Service Information

Model : GP605

Ref. No. : FF-T01-K1-000018-01

Subject : COUNTERMEASURES FOR GEAR BREAKAGE DUE TO FALLING TIE-WRAP

Fig. 1

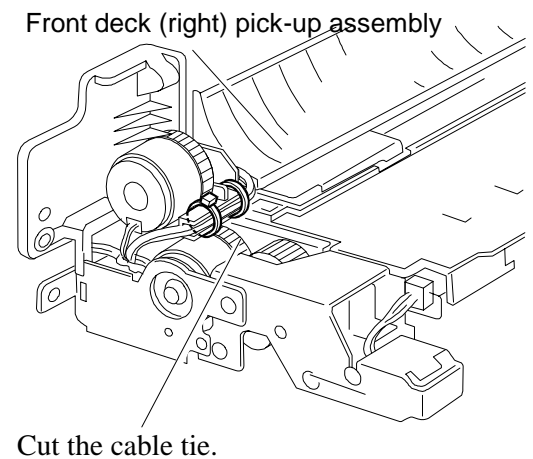
<Cause>
When the fixing/feeder frame assembly is drawn in and out, tight space inside the machine causes the cable tie which holds the front deck (right) pick up assembly cables to make contact and gets cut. The cut cable tie falls into the front deck (right) gear and the gear drive locks, causing the weakest 20T/32T gear (Parts Catalog FY8-31DU-010 P260-2) in the paper pick-up drive assembly to break.

<Factory measure>
The cable guide was cut, and the cables are held in place by freeing the cable tie from its former position.

1) Remove the front deck (right) pick-up assembly.
   (See Service Manual FY8-13FE-000 P7-53.)
2) Cut the cable tie (Fig.1).
3) Accomplish reattachment by following the procedure in reverse.

Cut the cable tie.
